Access Compliance Report

Public Rights-of-Way

(Pedestrian Signals)

Intersection ID: N/A	Main Street:	Cross Street: N/A	Location: N/A
ADA ID: 8B221D5B1088	Signal Type: Two Push Buttons-Non APS	Overall Compliance: No	Severity Score: BTN 1:N/A BTN 2: N/A No BTN: N/A
Codes/Mitigation Info/Possible Solution		Field Measurements/Component Compliance

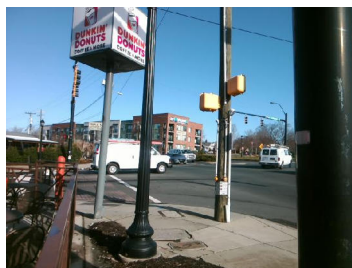
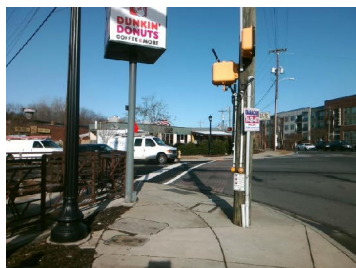
Possible Solutions: Replace Signal Push Button With APS Button. Remove and Replace Clear Space.

PROW/ADA: R404.2, R404.3, R404.7.2, R104.2, R209.1

Yes	B 1 Pressure (#)	2.0	Yes	B 2 Pressure (#)	2.0
No	B 1 Closed Fist Operation?	N/A	Yes	B 2 Closed Fist Operation?	Yes
